Memorandum

Re: Staff response to submittals during November 3-10, 2010 open period (CUP-10-03) and questions from Planning Commission

TO: Peter Spir, Associate Planner
FROM: Keith Liden
RE: New West Linn Primary School (CUP-10-03, DR-10-06, VAR-10-06 through 09, and WAP-10-01)
DATE: November 10, 2010

2 TYPICAL SECTION FOR ROSEMONT ROAD
SCALE: N.T.S.

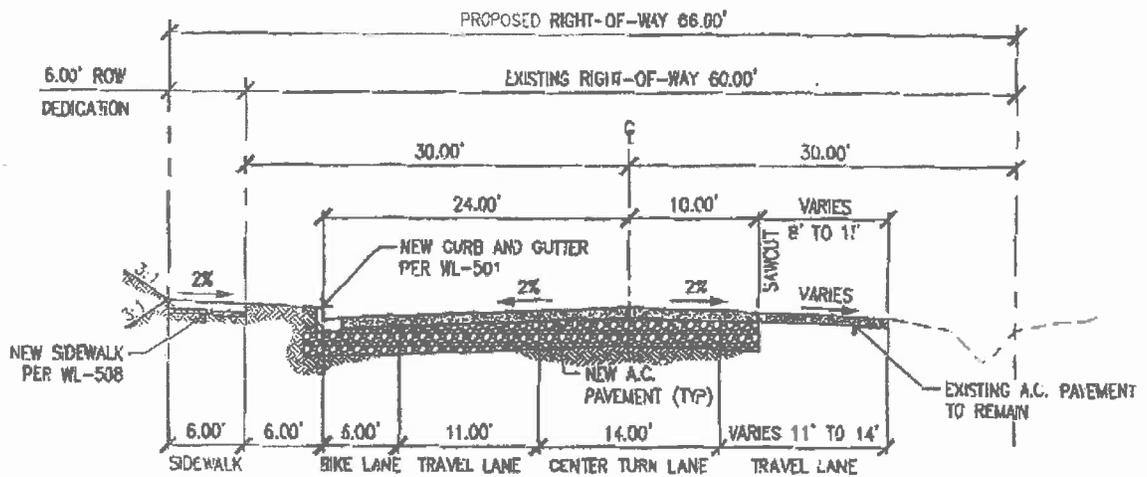
Gary Hitesman raised the issue that Rosemont Road lacks a consistent design because part of it is contiguous to the City; part to the County. The property to the west is in the County and the property at 1045 Rosemont Road is in the County. The 1045 Rosemont Road property accounts for 250 feet of the project's 930 foot frontage. Staff pointed out that regardless of whether property abutting the street is "county" or "city", the road will be designed and built per City standards with an 11-foot wide

north and south travel lanes plus a 14-foot wide center turn lane starting at Bay Meadows Drive and tapering to Hidden Springs Road.

From the curb edge there will be six foot planter strip with street trees and a six foot sidewalk behind that. For the frontage at 1045 Rosemont Road there will just be six foot wide sidewalk curb tight with no planter strip. At such time that 1045 Rosemont Road annexes to the city, the sidewalk design will be revisited with the ambition to add a planter strip. Nothing in these designs represents a compromise in traffic safety.

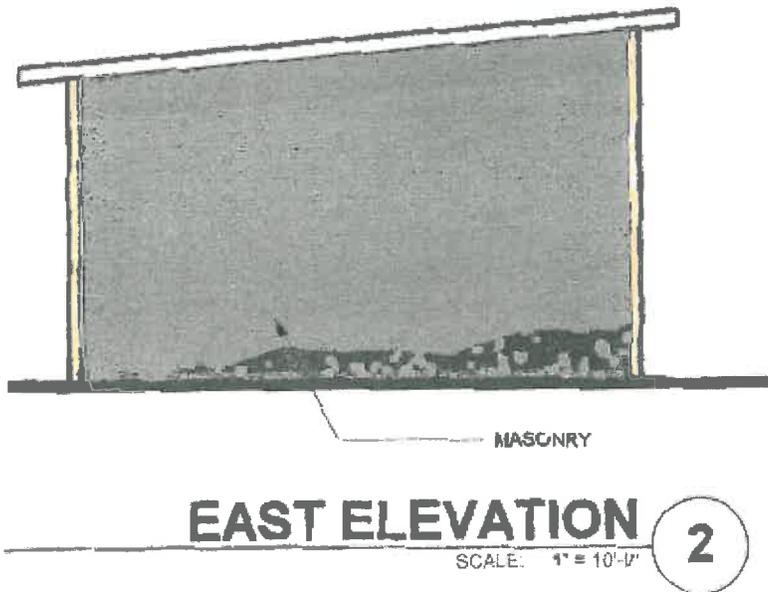
Gary Hitesman raised the issue that the east facing elevation of the outdoor activity building, which is supposed to provide children with an "outdoor" space to play in when it rains, is blank. Staff would agree that, as shown, the 21-24 foot high structure looks like the backside of a barn. It faces the homeowners to the east of the site. Although it is understood that the blank wall is intended to provide shelter from winter winds and to be used as a backboard for ball games, staff would encourage a new, more attractive design for the east elevation that could include different brick/stone patterns/colors. A possible condition could read: *"The east elevation of the covered play structure shall be re-designed with at least one horizontal row of contrasting colored building material at four to six feet above grade to break up the blankness of the wall."*

OPTION A.1

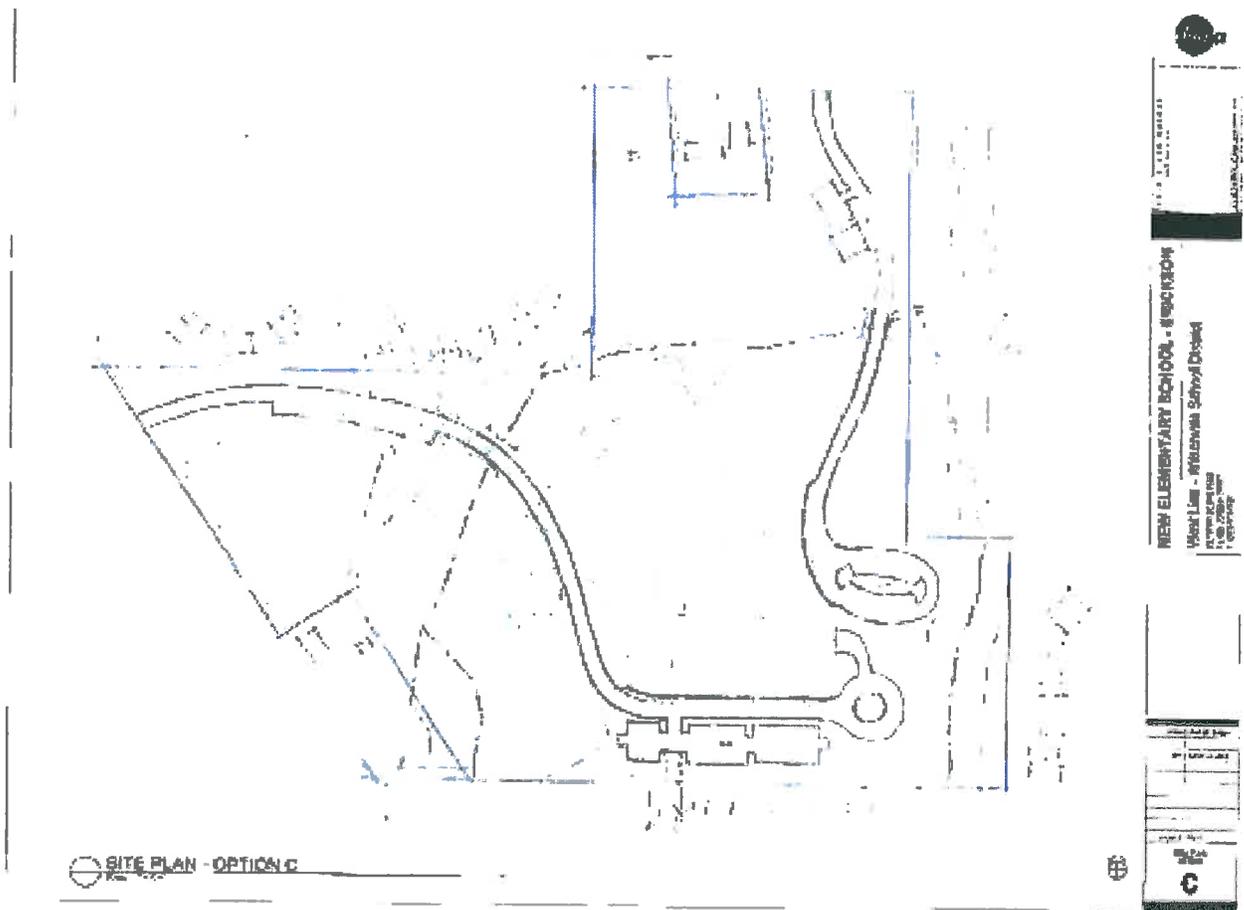
Both designs feature two creek crossings. Option A.1 calls for two access points on Rosemont Road. The Engineering Department would prefer decreasing points of access onto Rosemont Road rather than increasing them, particularly since this road is an arterial with a currently posted speed of 40mph. Option A.1 has two creek crossings almost side by side affecting a 200 foot long section of the wetland/creek area which begs the question: "Why can't the two crossings be reduced to one?" The neighbors most affected by this road alignment are in Arena Park subdivision to the northwest.

Both options also access Bay Meadows Drive to the south. Option A.1 envisions exit only traffic while Option C shows it as an emergency only route. Similarly, Suncrest Drive through Arena Park subdivision is shown as an emergency link in Option A.1 whereas Option C only shows that as a pedestrian/bike link. Certainly the modes of transportation at these two access points are flexible and open to change. Please note that the Transportation System Plan (TSP) will have to be amended if the Suncrest Drive to Bay Meadows Drive connection is not made.

Unanswered is the efficacy of the internal circulation and co-mingling of traffic. The plans are incomplete to determine how much parking is required and if that space parking is available.
